SHEFFIELD CITY COUNCIL Planning & Highways Committee

Subject: Planning application consultation from Barnsley Council about a proposed wind turbine at Sheepphouse Farm, Cubley

PROPOSED DEVELOPMENT OF A WIND TURBINE
SHEEPHOUSE FARM, MORTIMER ROAD, PENISTONE
APPLICATION 2013-0784
CONSULTATION FROM BARNESLEY MDC

Viewpoint 5 - View from Public Footpath at Bolsterstone

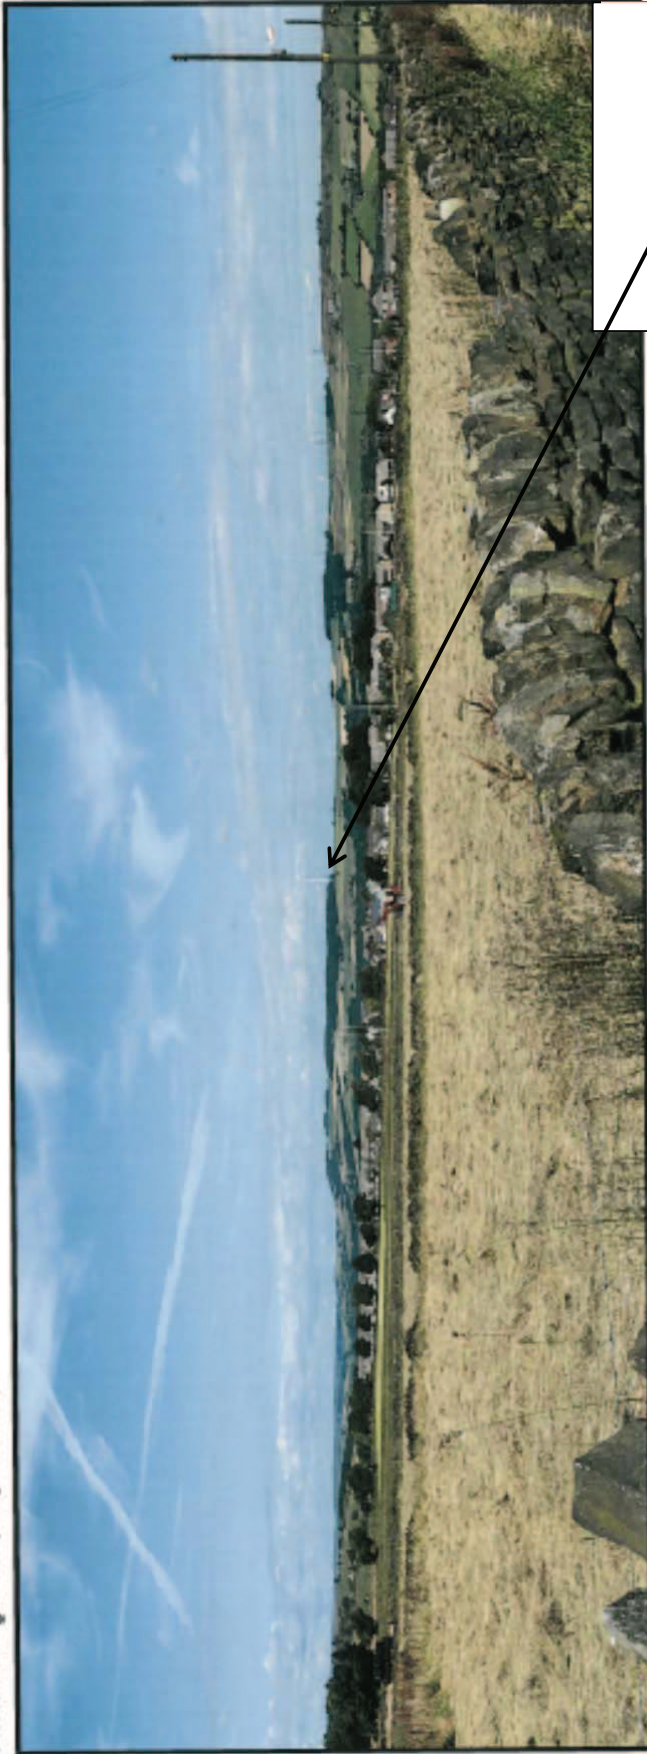
- 4.2.9 Views North West from Bolsterstone CA will also include the wind turbine. It will be seen on the skyline at a distance of just over 4 kilometres. This distance does mean that the wind turbine will appear relatively small, but it will be seen as a standalone feature on the horizon as there are no intervening features that break the skyline close to it. The electricity pylons that do breach the horizon are separated from the structure and are not viewed directly in conjunction with the wind turbine.
- 4.2.9 Although seen as a standalone feature, the relatively small size of the wind turbine when viewed from Bolsterstone will not cause significant harm to the character and appearance of the CA and will not significantly harm wider views of the landscape when viewed from Bolsterstone. (Appendix 2)

Viewpoint 2 - View from Underbank Reservoir near
Smittry Moor Lane

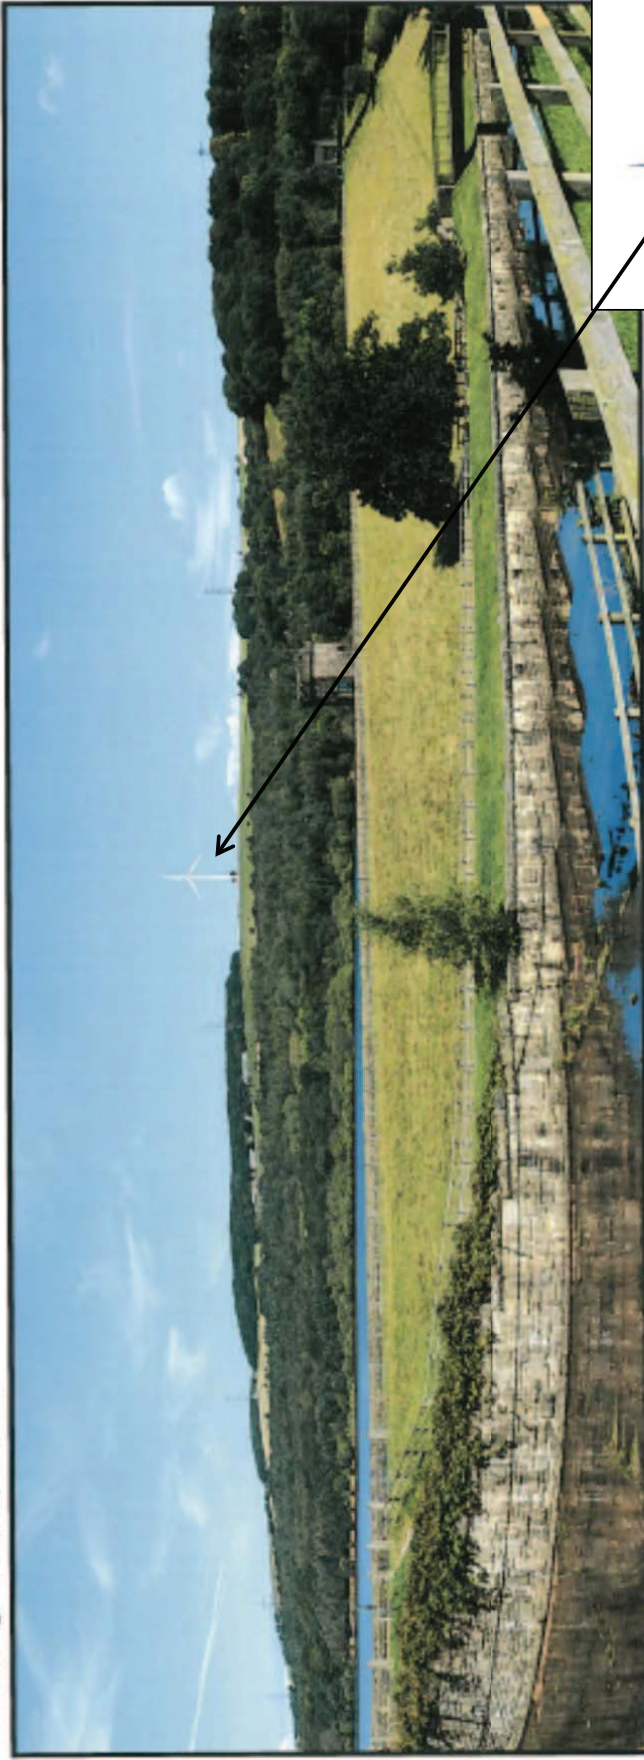
4.4.1 The wind turbine will be seen from other locations in and around Stocksbridge. At Smithy Moor Lane, by Underbank Reservoir, the wind turbine will be 1.4 kilometres away and will be seen on the horizon. At this distance, the wind turbine will be a relatively large feature but will be seen between the line of electricity pylons and as such it is not considered to cause significant harm to the character and appearance of the surrounding area (Appendix 3).
